## Product / Process Change Notification (PCN)

**PCN #:** PCN\_ConWTB254\_20180720  
**Affected Series:** 6610xx113322, 6610xx213322

**PCN Date:** April 20, 2018  
**Effective Date:** July 20, 2018

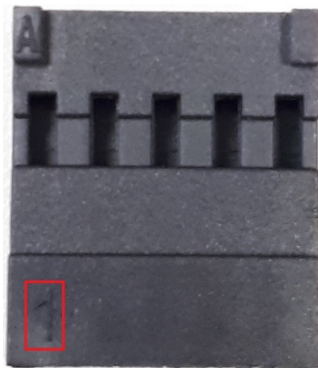
With the aim of an extended product applicability, Würth Elektronik will change the pin 1 marking of Intercom crimp housings in order to match it with Intercom headers and Autocom IDC receptacles.

The previous pin 1 marking is removed and another one is added at the opposite side of the crimp housing.
